# Information Item

**To:** Mayor and City Council  
**From:** David Martin, Director, Planning & Community Development  
Martin Pastucha, Director, Public Works  
Kathryn Vernez, Deputy City Manager  
**Subject:** Expo Light Rail - Revision of the Terminus Station North Entrance Design

**PWP Original Design for the north entrance**  
The original design for the north entrance included amphitheater seating.

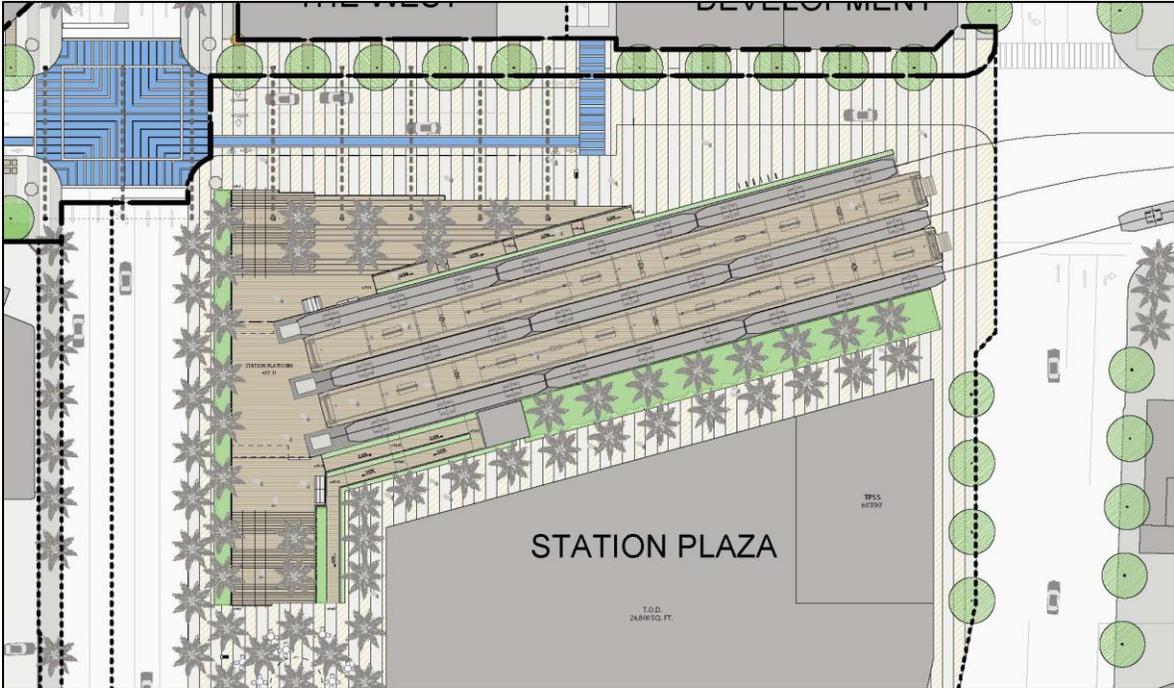
The final north ramp-and-stair configuration creates a triangular space between the ramp and the stairs. Within this triangular space, the original Peter Walker Partners

design included an amphitheater seating element, in wood or composite wood, to visually connect the station plaza to the Pier, to connect the experience of arriving in

Santa Monica with arriving at the water's edge, and to provide seating that contributes to a sense of place. However, based on material restrictions in Metro's Design Criteria, maintenance concerns from Metro and the City, and concerns from the Recreation and Parks Commission about universal access to the amphitheater, Peter Walker Partners redesigned the triangular space between the ramp and stairs based on a different concept, one focused on creating a shared arrival experience for all pedestrians, whether they use the ramp or stairs.

The new design for the north entrance reconfigures the triangular space into three garden terraces flanked on one side by a garden ramp and the west side by the stairs. The new north entrance design simplifies materials and form while enhancing the north ramp with a tall garden or art wall that will engage ramp users with the garden terraces. The garden terraces are designed with a combination of bold and iconic landscaping, featuring fragrant and colorful plants that announce the sea air and signal arrival. Whether alighting from the ramp or stairs, the pedestrian will step out of the station directly onto the Colorado Esplanade, where additional visual cues of planned ripple-patterned pavers and festive string lights create a dramatic yet uniquely Santa Monica arrival experience and a palpable connection to the water's edge.

**PWP Revised Design for the north entrance**

The revised design for the north entrance includes garden terraces and an enhanced garden or art wall

The new north entrance design for the Downtown Station/4<sup>th</sup> Street is designed to comply with Metro Design Criteria approved materials, addresses the maintenance and betterment cost concerns associated with the amphitheater seating element, and creates an improved universal access and arrival experience by replacing the amphitheater seating with garden terraces and an enhanced north ramp.
